**Subject: Response to Public Comments on the Biological Site Assessment for a Single-Family Residence At 726 Point San Pedro Road Marin County, California”**

## Response to Public Comments on Biological Site Assessment

# WRIGHT RESIDENCE

726 POINT SAN PEDRO ROAD, SAN RAFAEL, CA 94901  
APN: 186-141-03

**Figure 4. Plan View Drawing of Proposed Project**  
 726 Point San Pedro Road  
 San Rafael, California

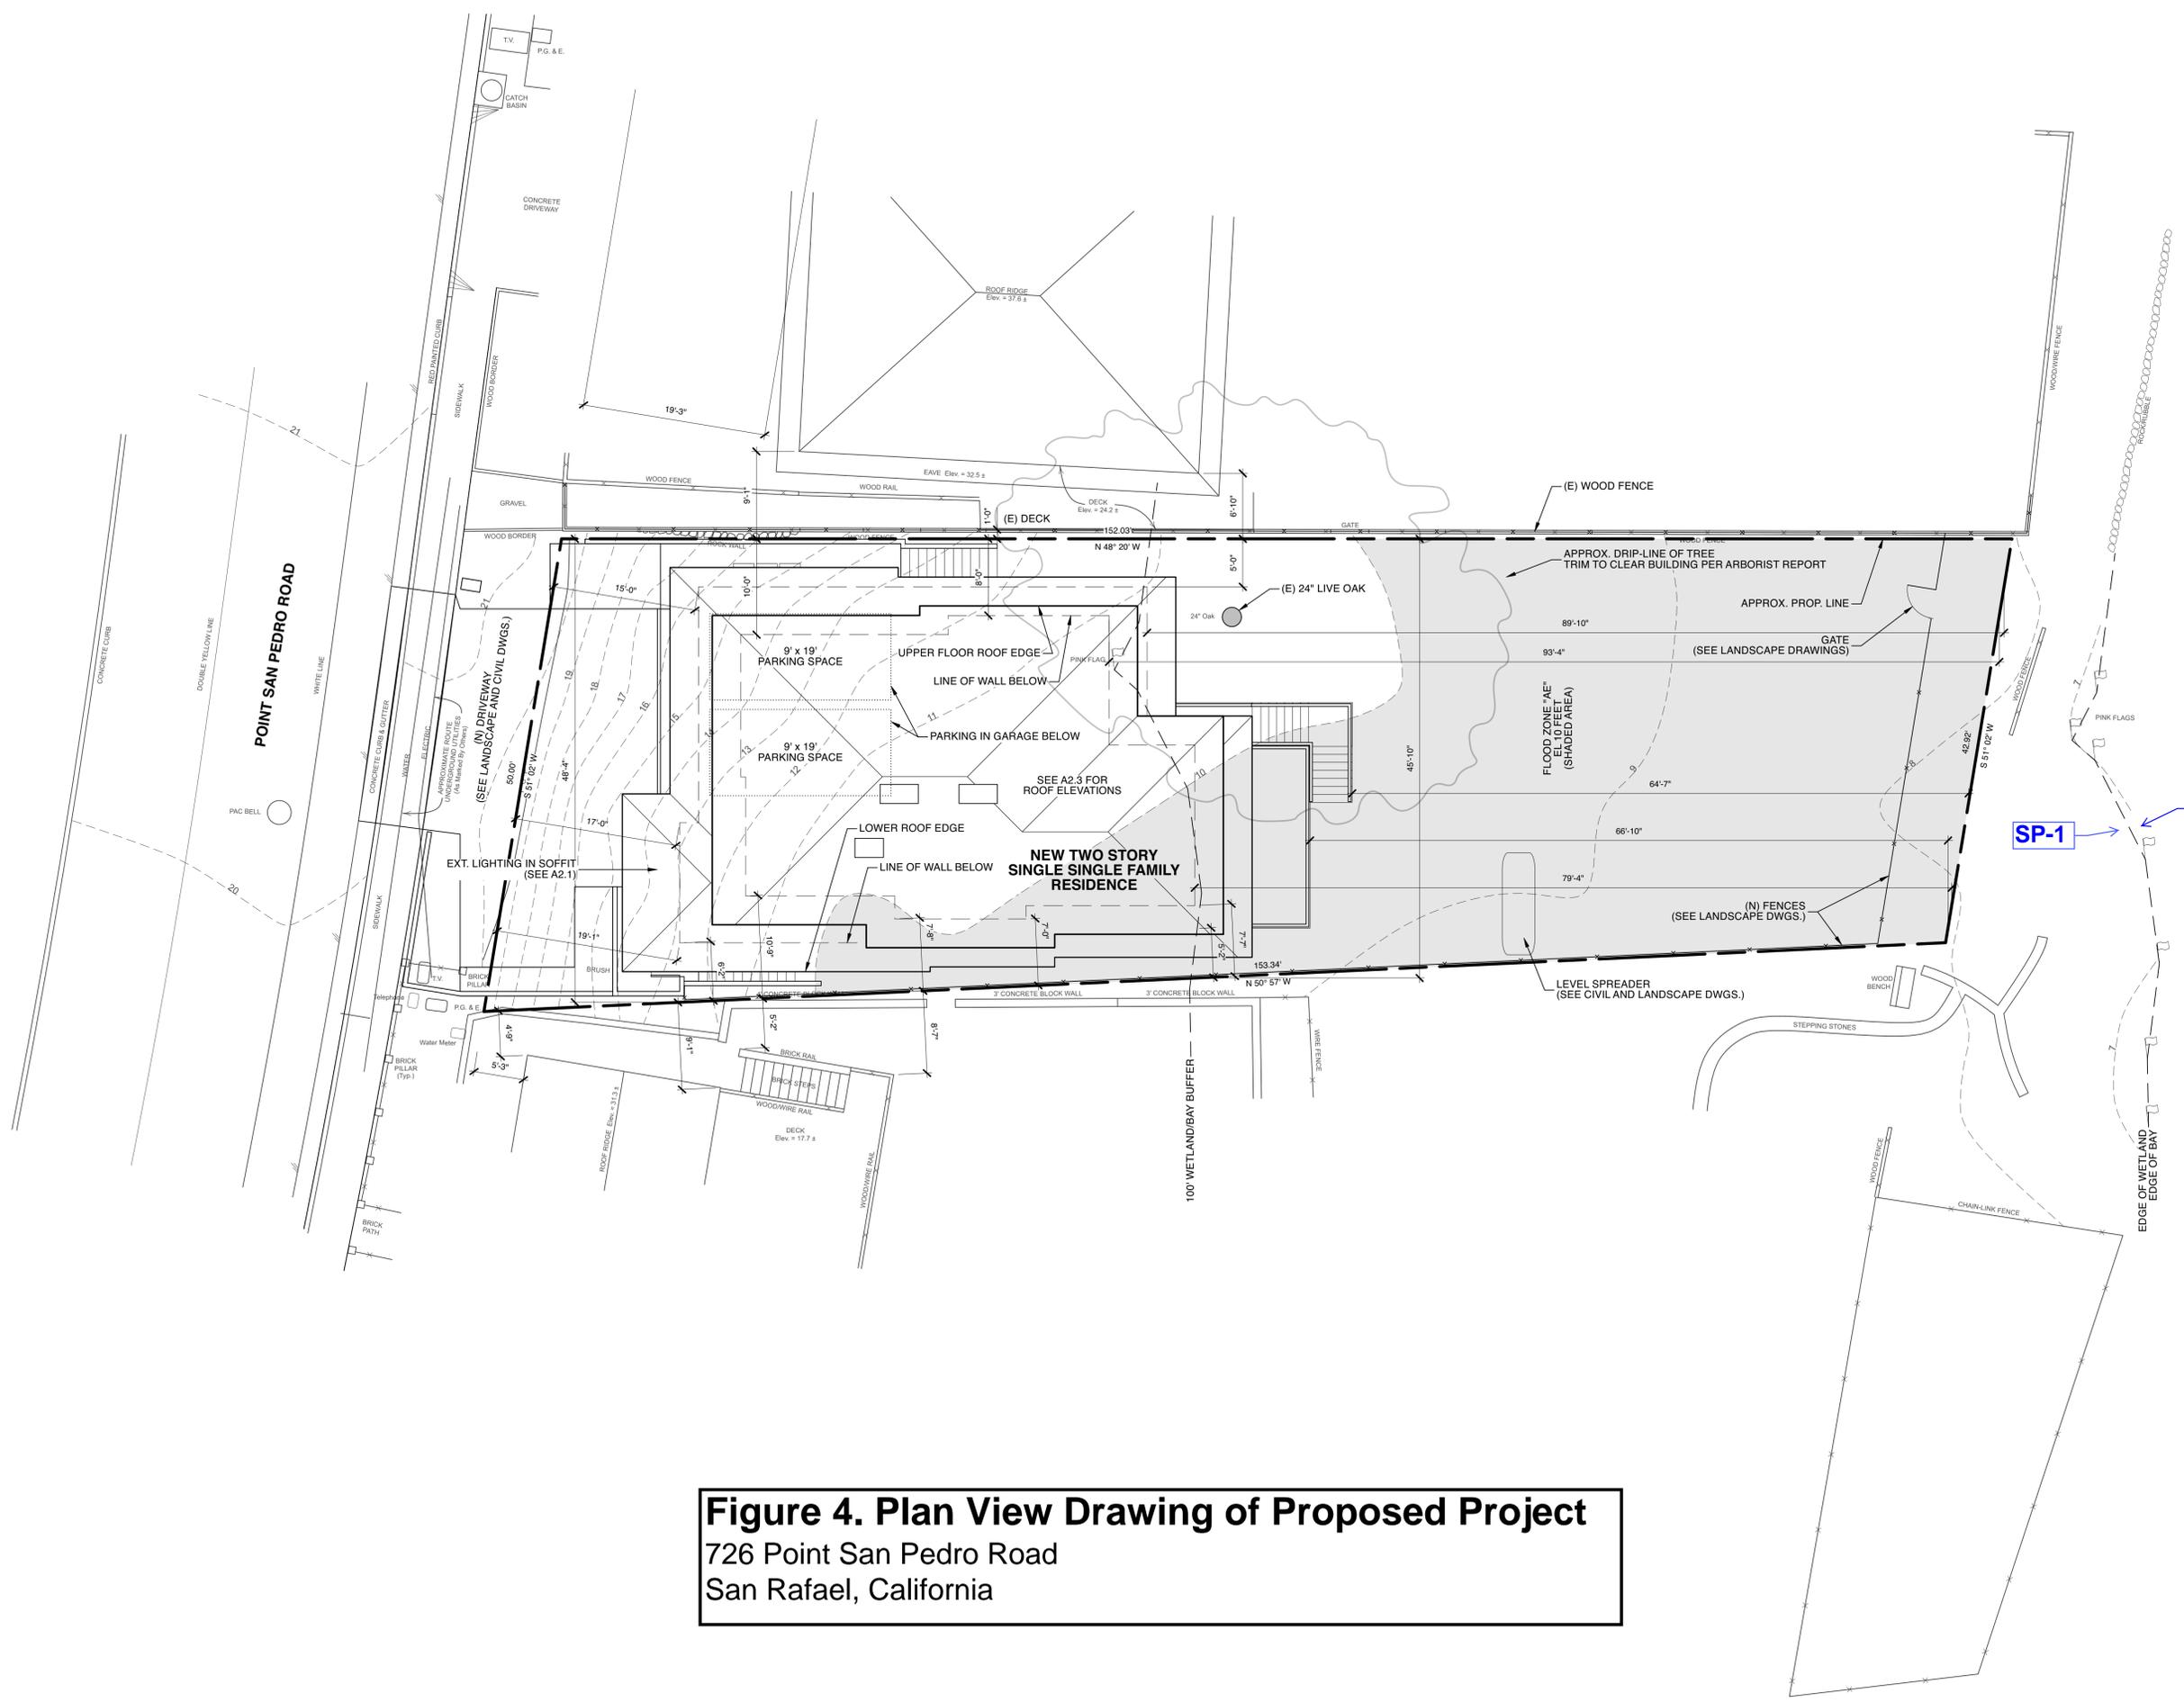
The presence of wetland vegetation alone does not define a wetland as suggested by the commentor. Based on the field data collected by HBG on April 6, 2021, wetland and upland vegetation is present above the limit of the wetland mapped as shown on the wetland determination data form SP-1. However, the absolute cover is not greater than 50%, therefore it does not meet the wetland vegetation criteria. In addition the soils are not hydric and there were no signs of wetland hydrology, therefore this point does not meet the criteria of a wetland. Refer to Exhibit 3 for a copy of the data sheets and a map showing the location of each data point.
